MBC COOLING WATER SYSTEM CHILLER UPGRADE

The following changes to the Contract Documents are hereby made effective as though originally issued with the bid package. Bidders are reminded that all previous requirements to this solicitation remain in full force and effect.

ADDENDUM C

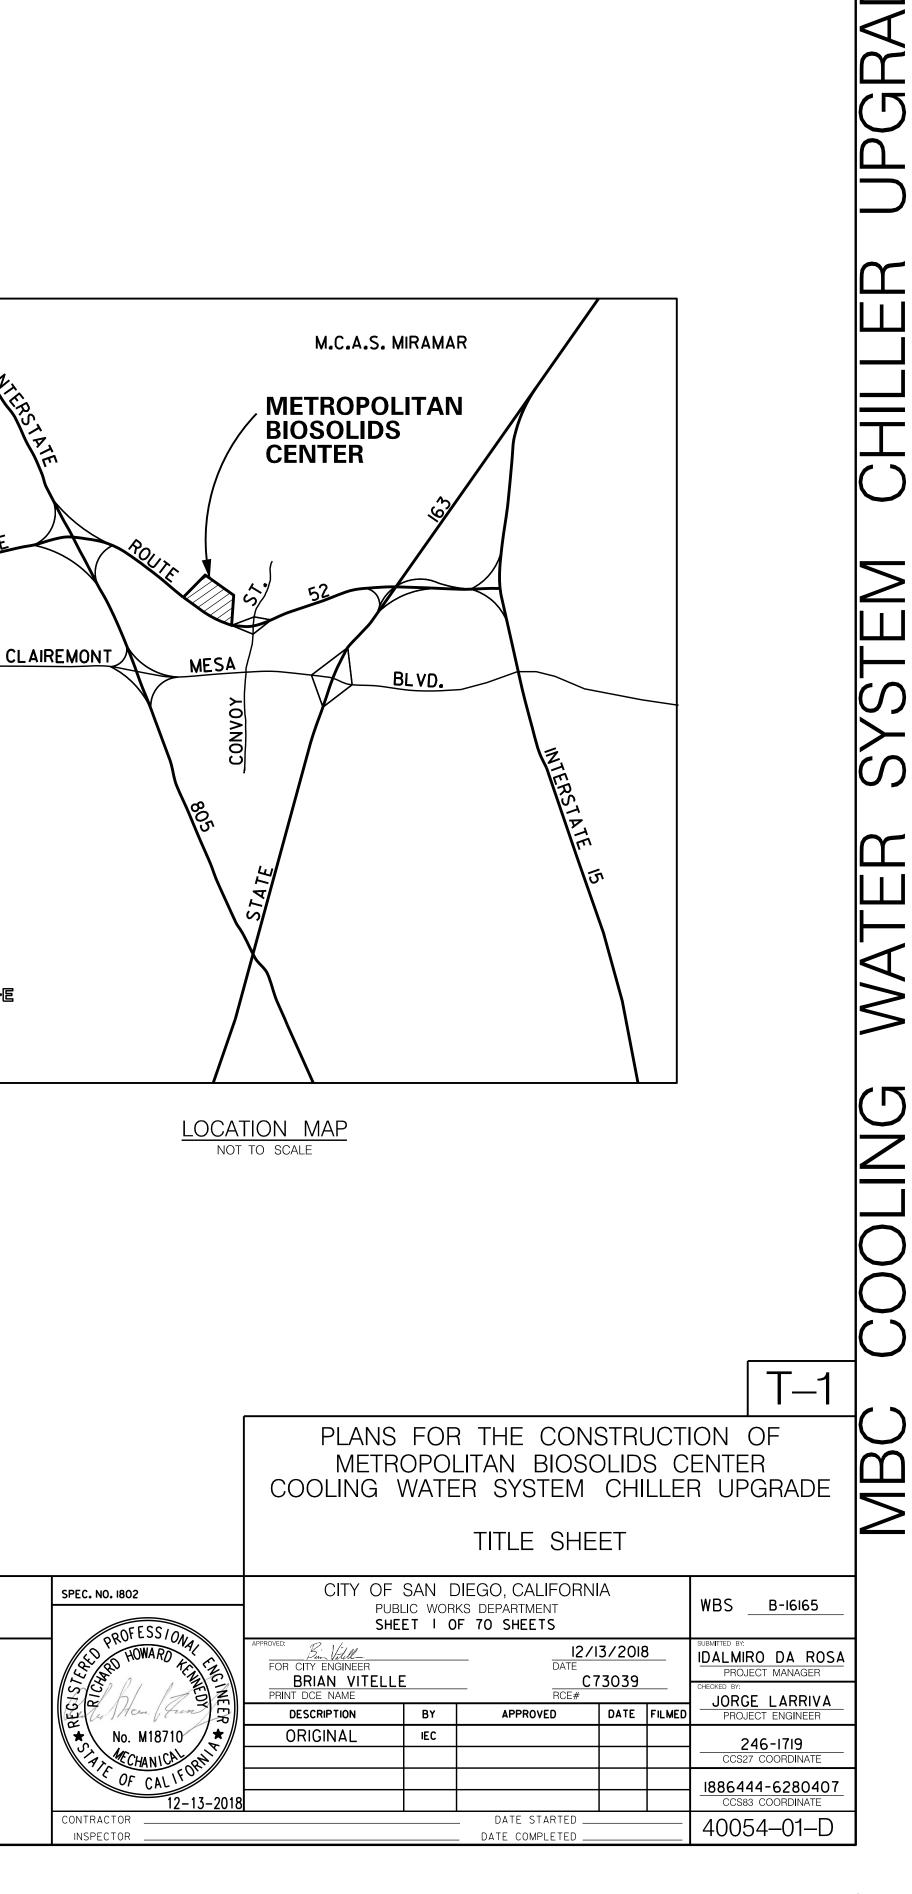
METRO	PLANS FOR THE CONSTRUCTION OF METROPOLITAN BIOSOLIDS CENTER COOLING WATER SYSTEM CHILLER UPGRADE							
		GENERAL ELECTRICAL NOTES							
	CITY OF S PUBL SHEE	WBS <u>B-16165</u>							
ROFESSIONAL Standard M. MOD ST ST ST Maestri M. MOD FR ST ST ST ST ST ST ST ST ST ST	FOR CITY ENGINEER BRIAN VITELLE PRINT DCE NAME		DATE	3/2018 '3039		UBMITTED BY: IDALMIRO DA ROSA PROJECT MANAGER CHECKED BY: IDACE L ARRIVA			
$\begin{bmatrix} 22 \\ -700 \\ $	DESCRIPTION	BY	APPROVED	DATE	FILMED	JORGE LARRIVA PROJECT ENGINEER			
* SI FECTRICA	ORIGINAL	MPA MPA	Binan Vittel-	3/4/19		246-1719 CCS27 COORDINATE			
12/12/2018						1886444-6280407 CCS83 COORDINATE			
CONTRACTOR			DATE STARTED DATE COMPLETED			40054–14 –D			
REMOVE NOTE 10 ADDENDUM C

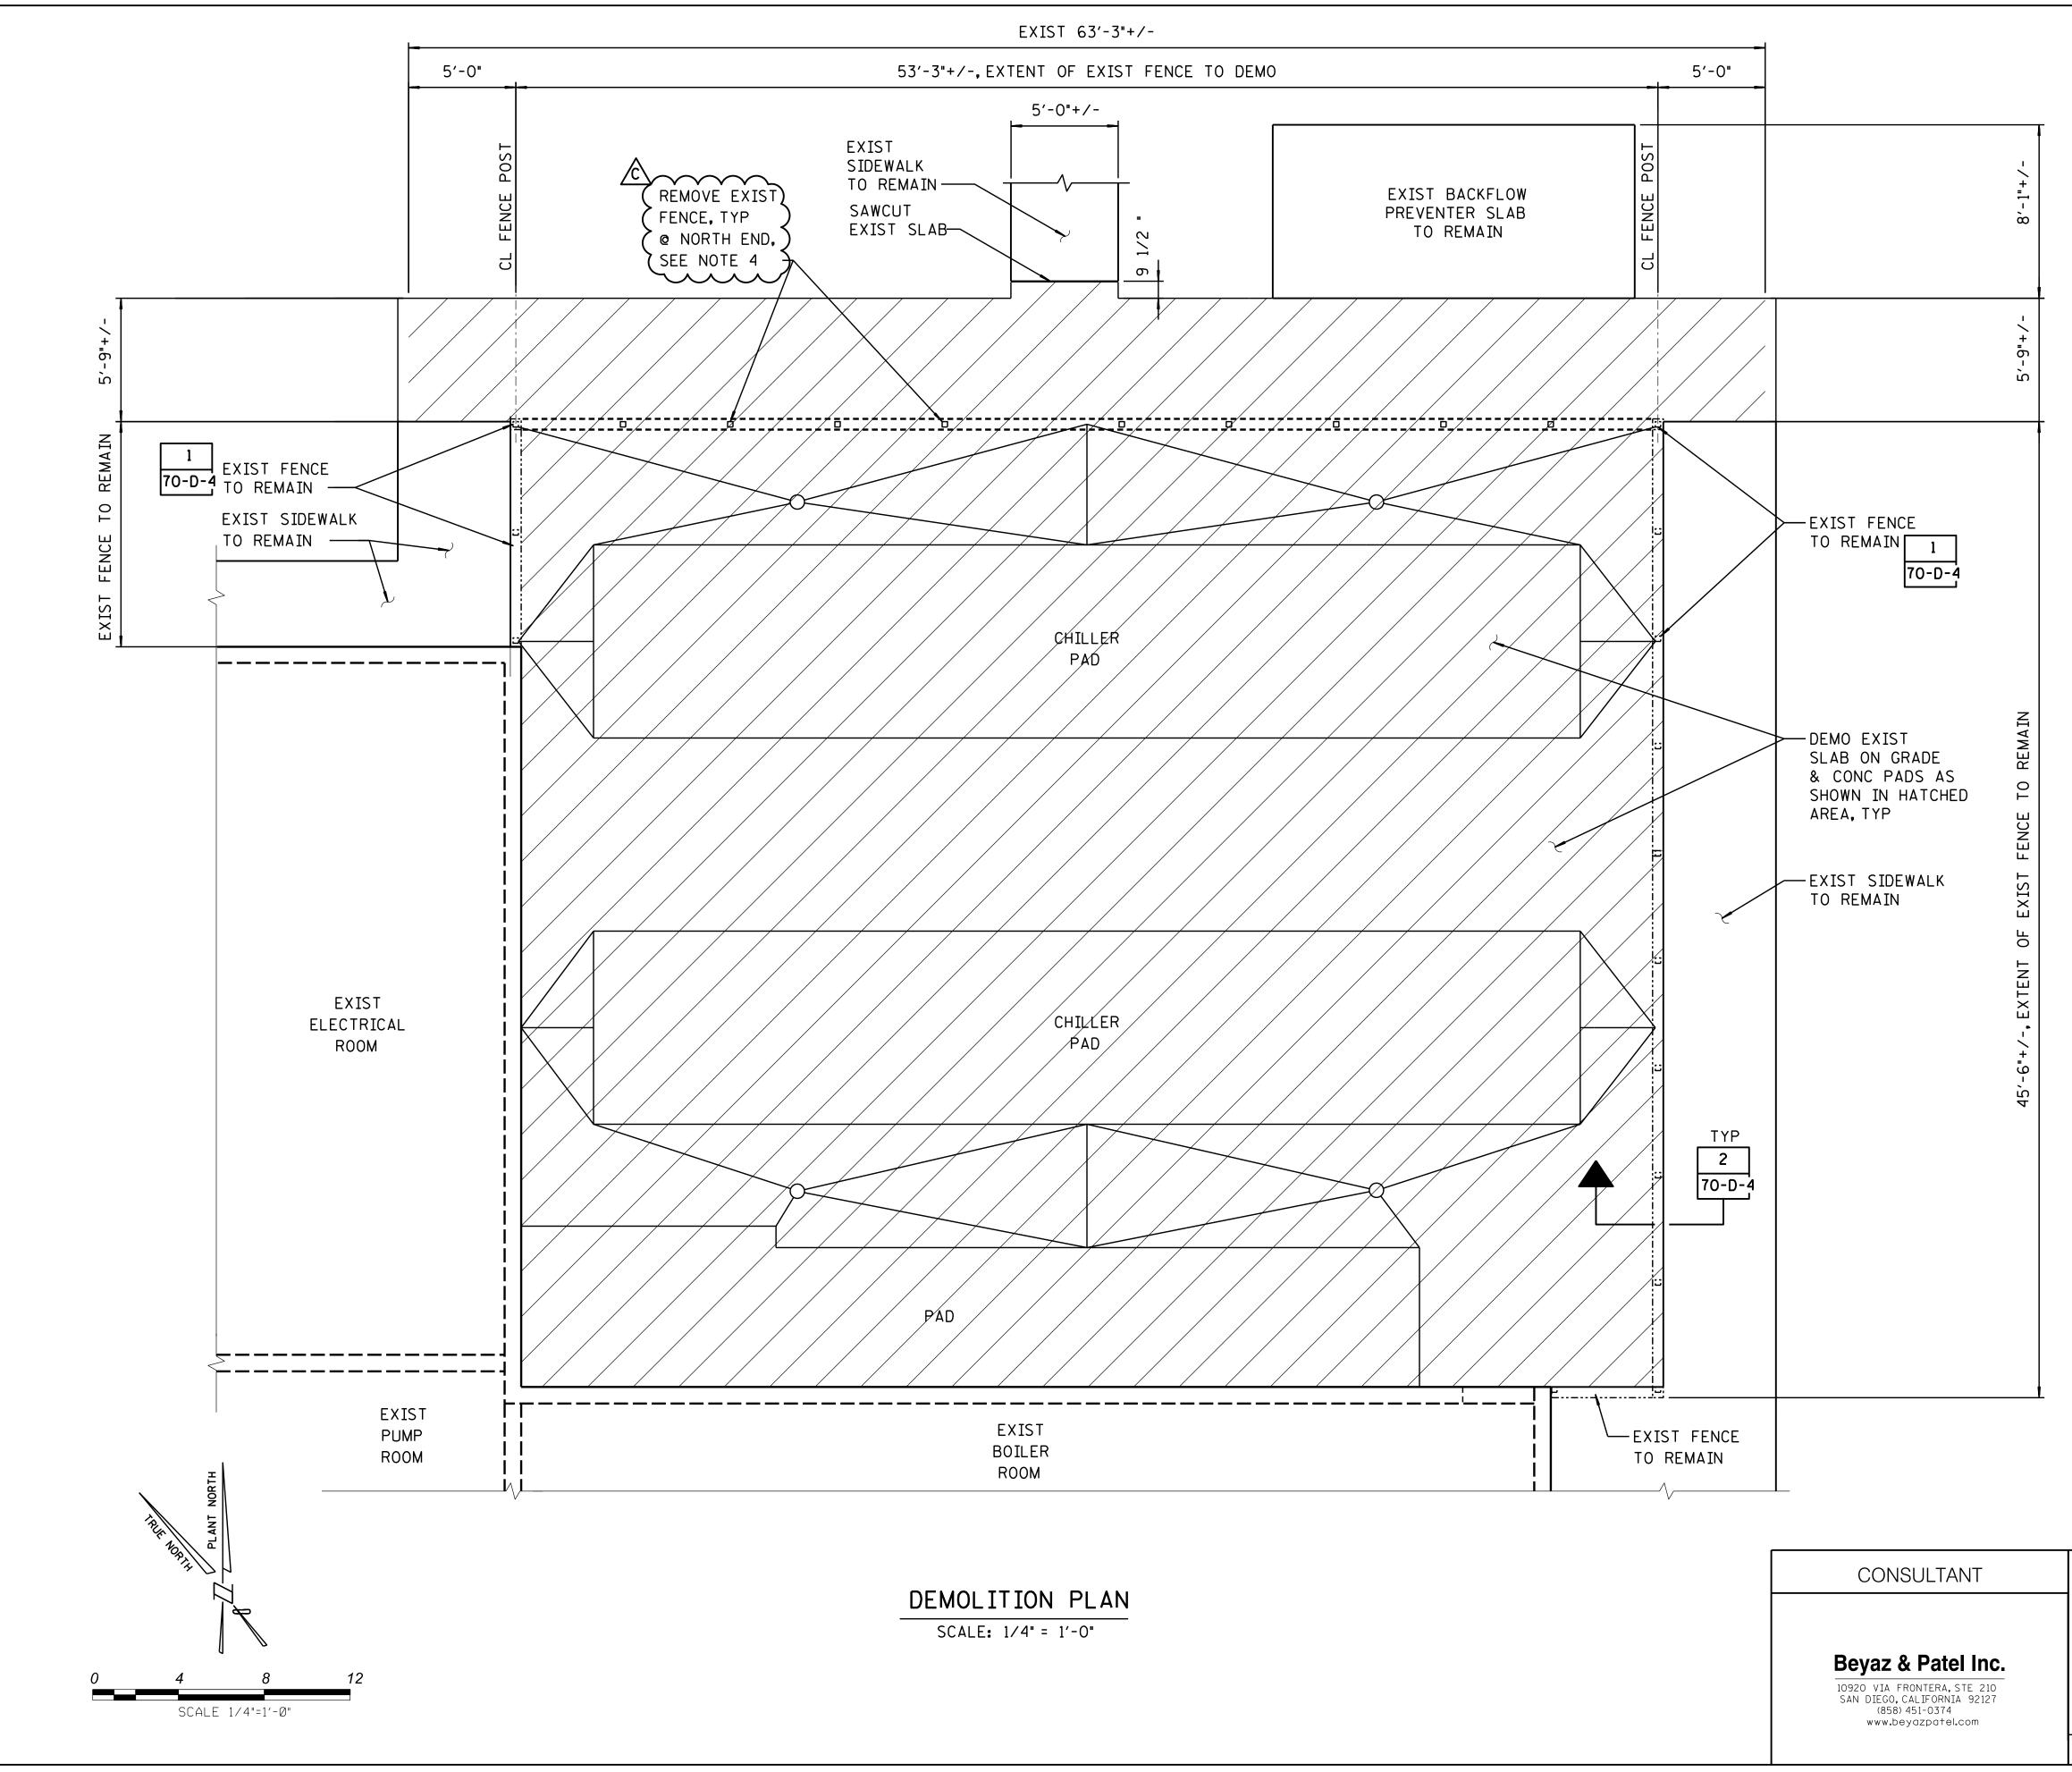
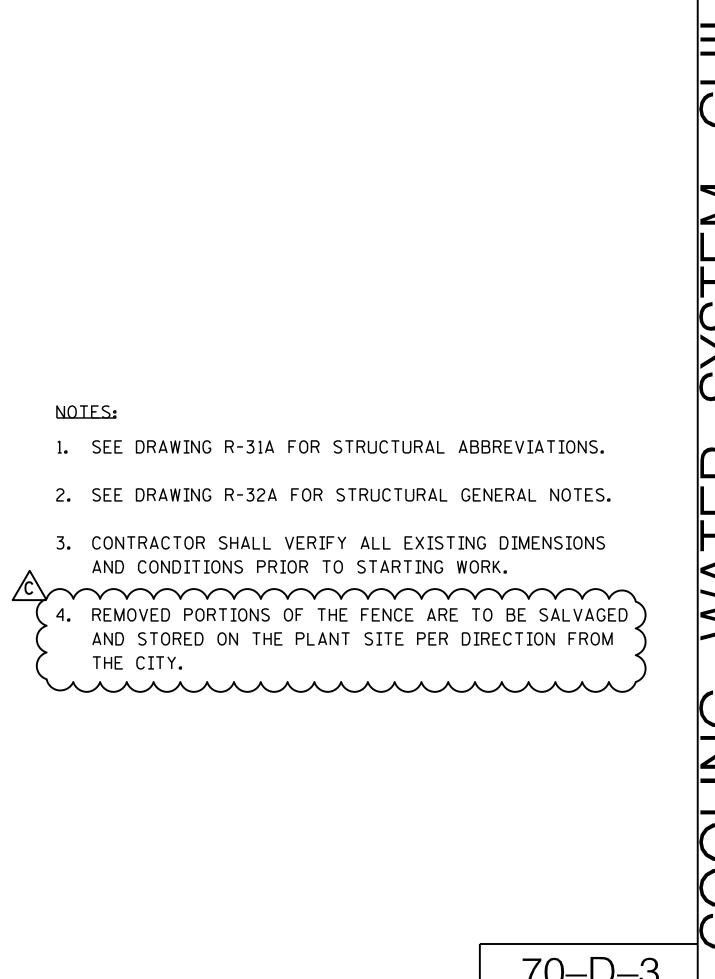
- A5. The removed fence will not be replaced, but rather the chiller area will be left open. A note will be added to bid drawing 70-D-3 indicating that removed portions of the fence are to be salvaged and stored on the plant site per direction from the City.

HVAC SCHEDULE – 1

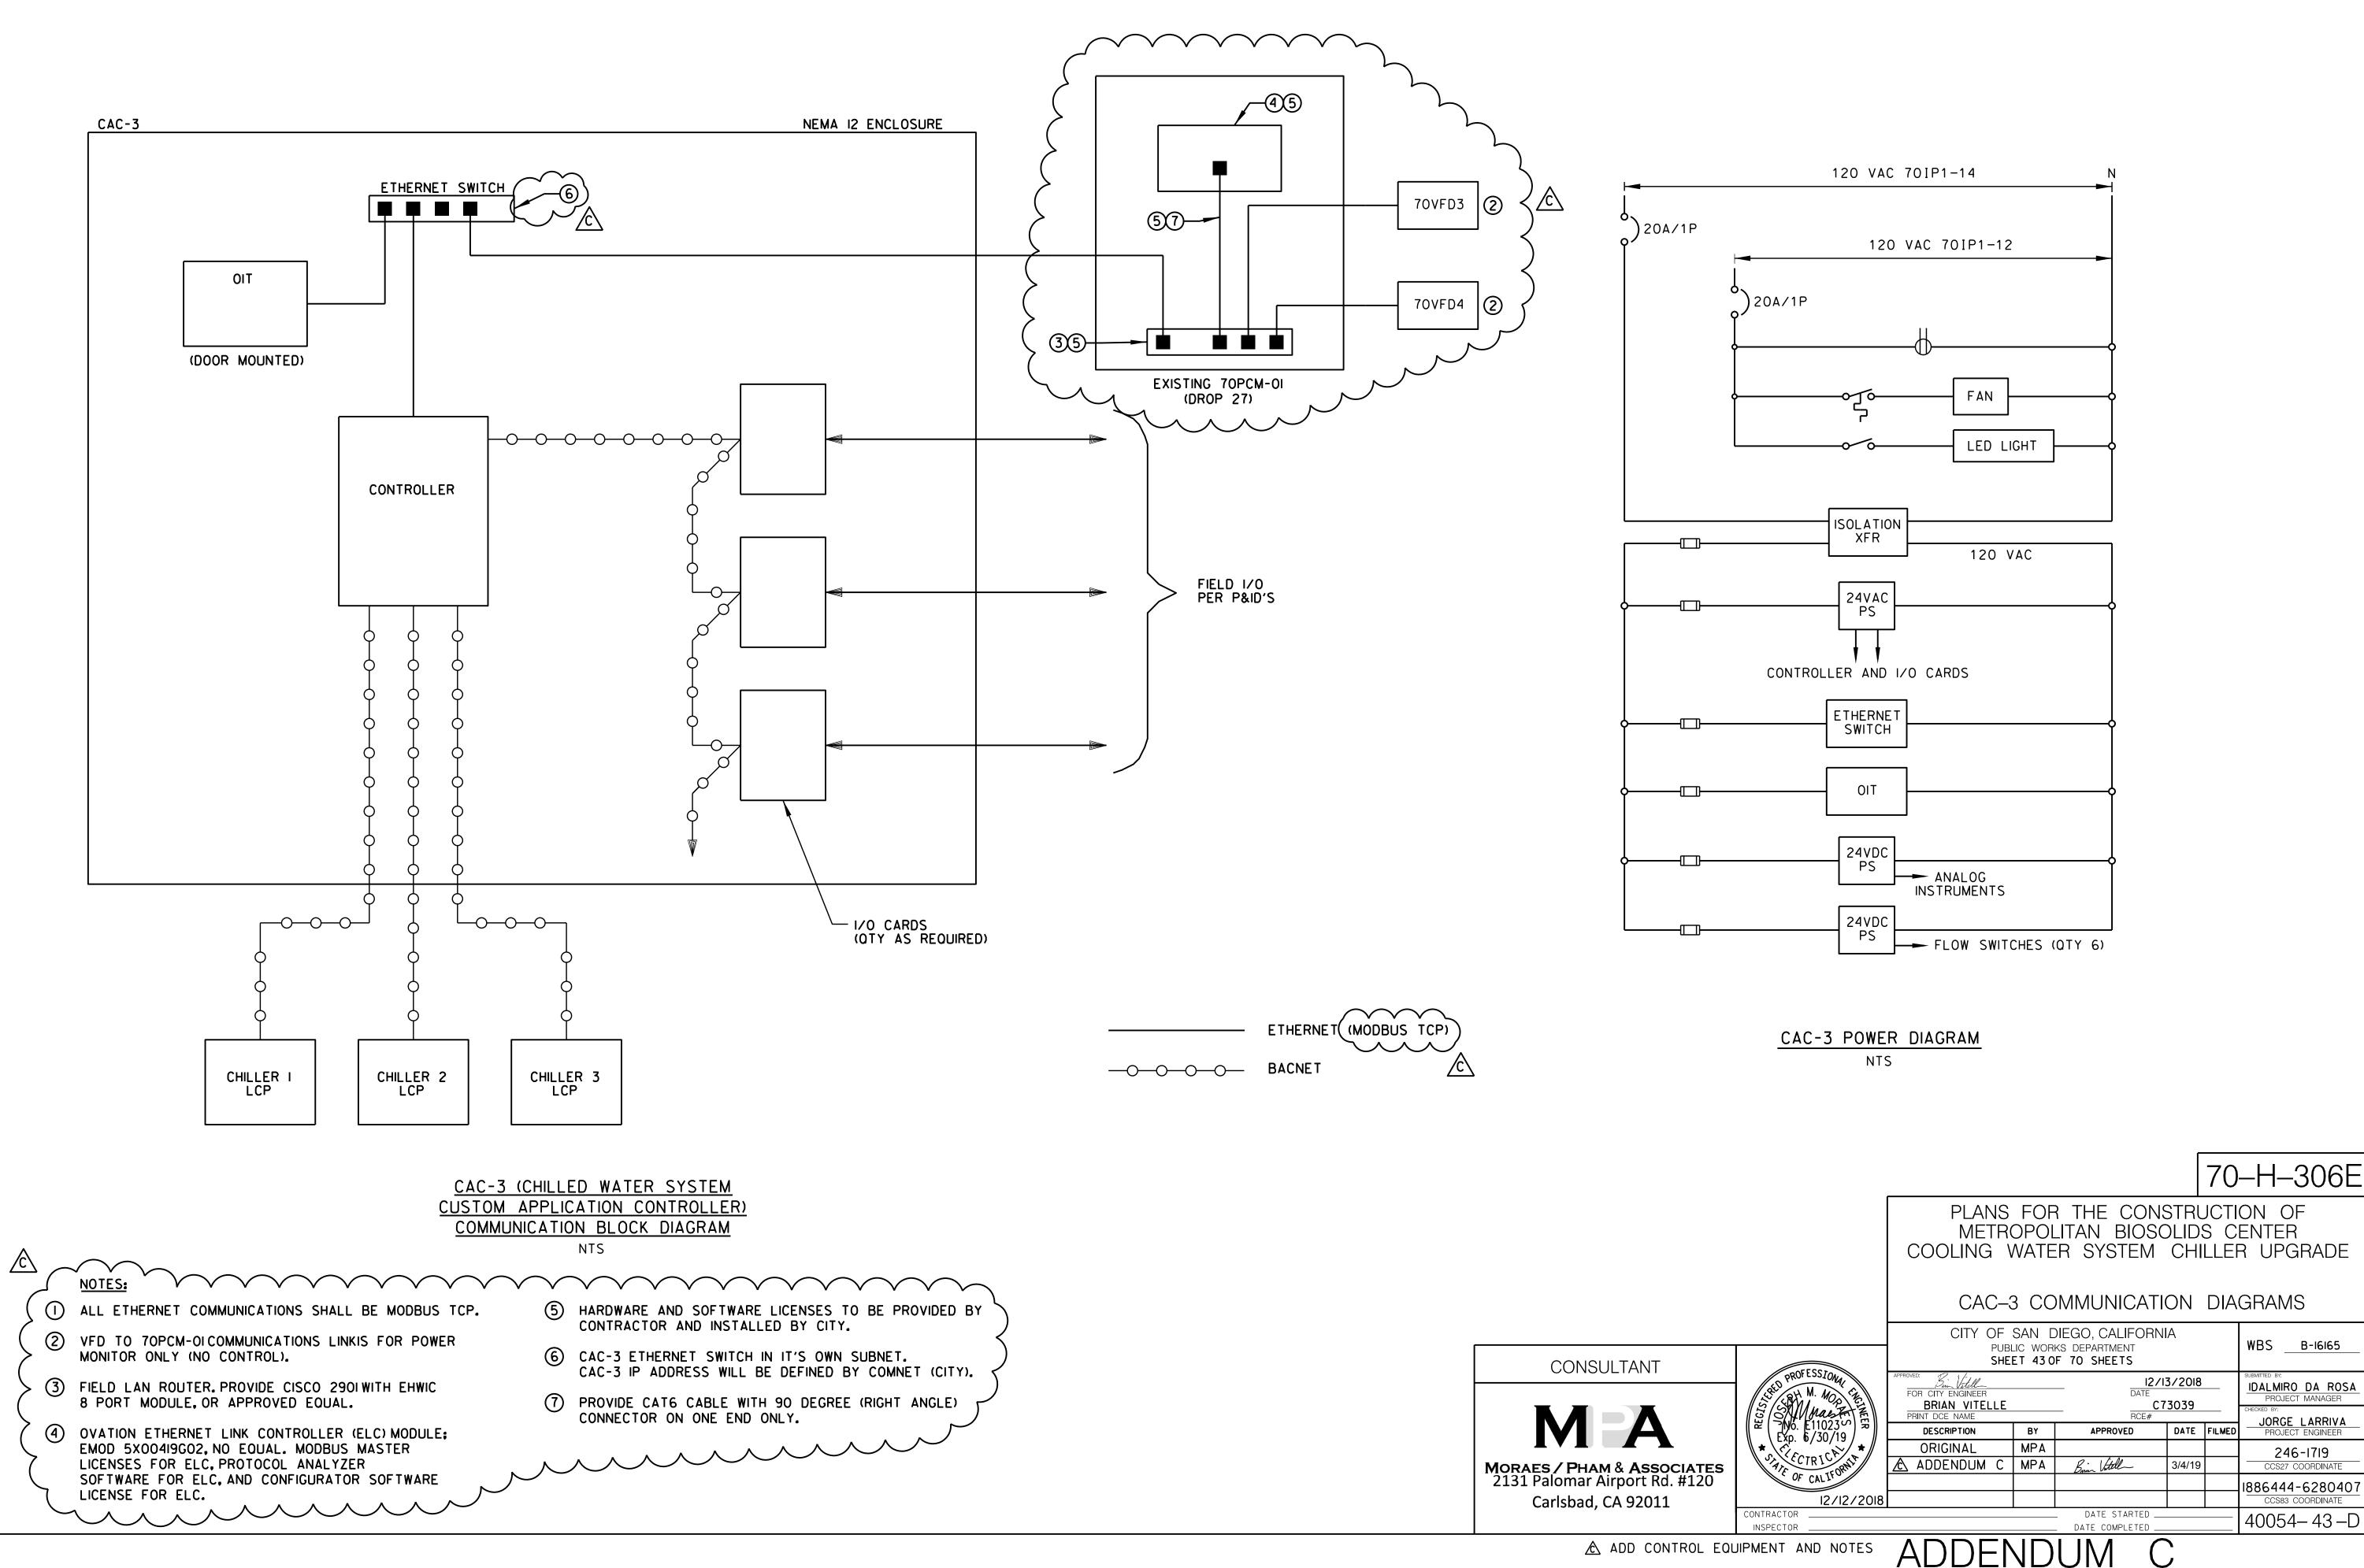
The PUMP SCHEDULE on Sheet 70-H-501A will be revised by addendum as follows:

CITY OF SAN DIEGO, CALIFORNIA									
	PROFESSIONA	SHEI		KS DEPARTMENT F 70 SHEETS			WBS <u>B-16165</u>			
	HUWARD FLUE	FOR CITY ENGINEER BRIAN VITELLE PRINT DCE NAME		DATE C73039 RCE#			UBMITTED BY: IDALMIRO DA ROSA PROJECT MANAGER CHECKED BY: JORGE LARRIVA			
RATION	Hu Han fun EF	DESCRIPTION	BY	APPROVED	DATE	FILMED	PROJECT ENGINEER			
_	No. M18710	ORIGINAL	IEC				246-1719			
on Street a 92064	The CHANICAL ON	\land ADDENDUM C	IEC	Brian Vatell	3/4/19		CCS27 COORDINATE			
413.2440 ation.com	OF CALIFORNICAL						I886444-6280407 CCS83 COORDINATE			
	CONTRACTOR			DATE STARTED DATE COMPLETED			40054-44-D			
\land RE	EVISE PUMP TABLE	ADDEN	١D	UM C)		Page 186 o
